ROAD SAFETY AUDIT REPORT

M2 Motorway, Epping – Digital Signage

Prepared for NSW Department of Planning and Environment

Document Title	RSA Report – M2 Motorway, Epping – Digital Signage
Document Number	M2DSRSA-BULL-NWW-SF-RPT-000001-C

Figure 16: On-Ramp Entry from Beecroft Road

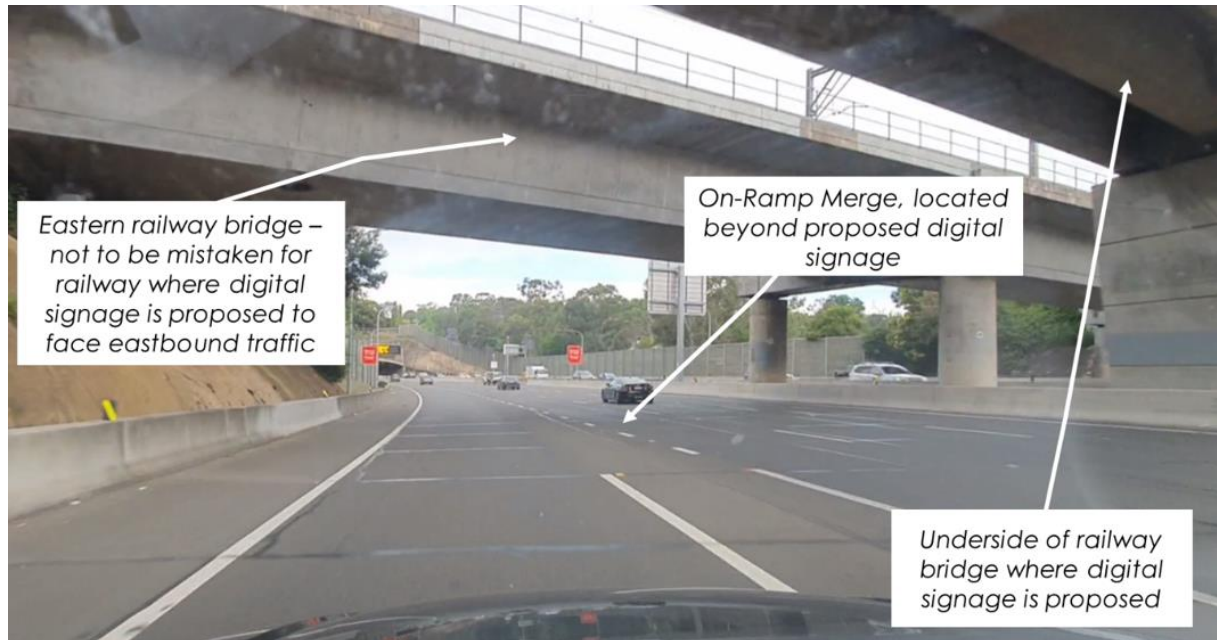
The beginning of the merge point from the on-ramp to the mainline traffic is located beneath the railway bridge and beyond the visible distance of the digital signage as shown in Figure 16. This is the location where a driver would be observing the mainline traffic and looking over their shoulder to merge into the adjacent lane.

As assessed in the response to City of Parramatta Council Submission #1, a comparable digital signage is located on the M4 Motorway in Homebush. A supplementary crash analysis was undertaken by TPPP of the M4 Motorway in the vicinity of the existing digital signage (the crash analysis is contained in Attachment One of this letter). The findings of the assessment suggest that the presence of a digital signage does not result in an unsafe amount of information exposure and/or driver distraction that is likely to result in further crashes. This conclusion is based on there being no additional crashes following operation of the digital signage on the M4 Motorway. In particular, there has been a significant reduction in the number of incidents overall since the digital signage has been operational.

Figure 9: Digital Signage and Variable Speed Signs on M4 Motorway

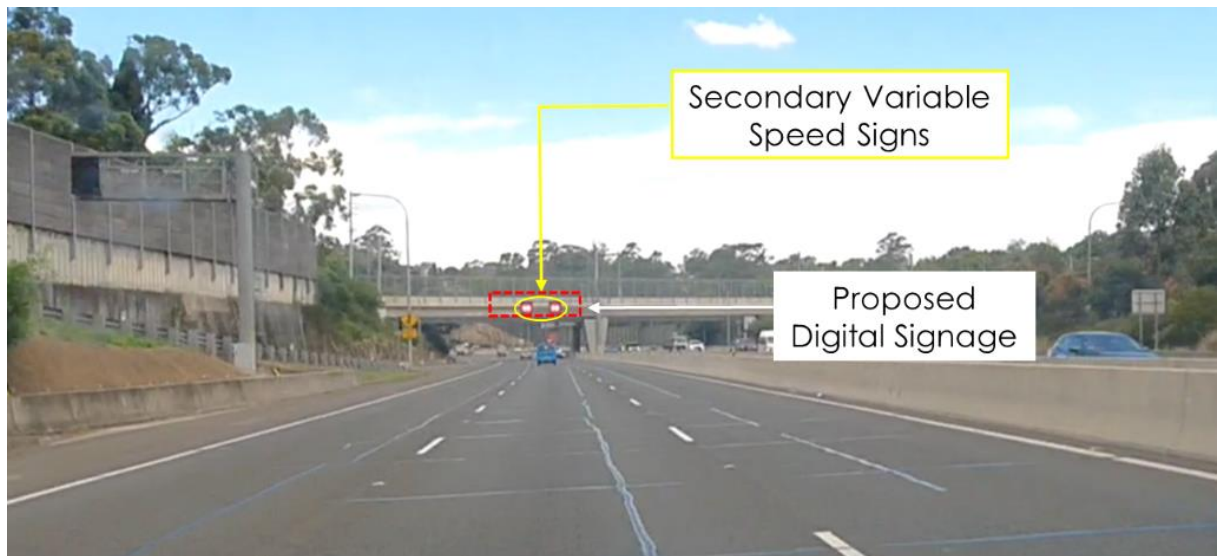
- ***The Traffic Consultant for the applicant argues that only the secondary Variable Speed Limit Signs (VSLS) are affected by the proposed advertising sign. Furthermore, they argue there will be minimal overlap with the VSLS in the foreground to be obscured by the digital sign. This point is disputed considering the VSLS is located only 35m from the proposed sign meaning that both signs will be in view of the driver for essentially the entire approach. This point is demonstrated in figure 2 above [provided in Attachment Two].***

It is noted that the secondary VSLs may be, at times, positioned in front of the proposed digital signage. However, the speed signs would not be obstructed by the digital signage and the VSLs would be visible to motorists at all times (see Figure 8). The earlier M4 Motorway example demonstrates how variable speed limit signs can be located prior to a digital signage without causing visual impediment (see Figure 9).

Figure 1: Nearmap Aerial Imagery to highlight the changes over time that have occurred on the M4 Motorway between 2015 and 2021

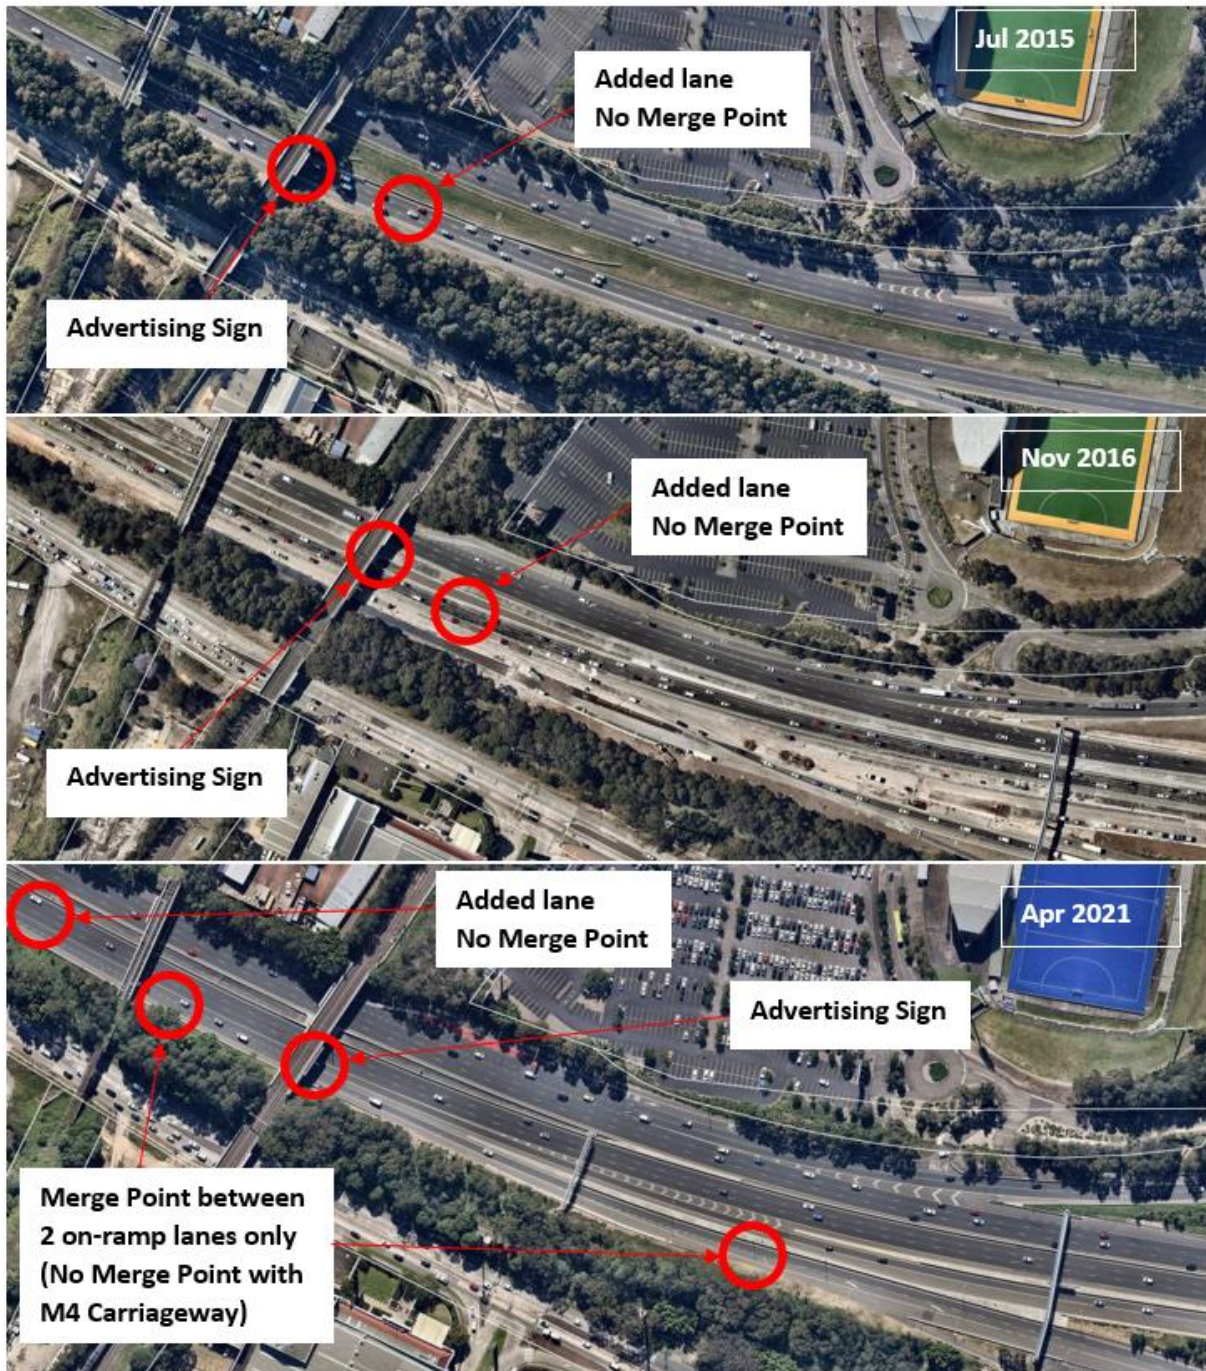
- During the construction period of the M4 Motorway upgrade, the roadworks speed limit was 80 km/h (see Figure 1) which is similar to the usual speed limit on the M4 Motorway post-construction i.e. 90 km/h. Therefore, a slightly reduced speed limit would have a minor influence on the number of crashes in this context.
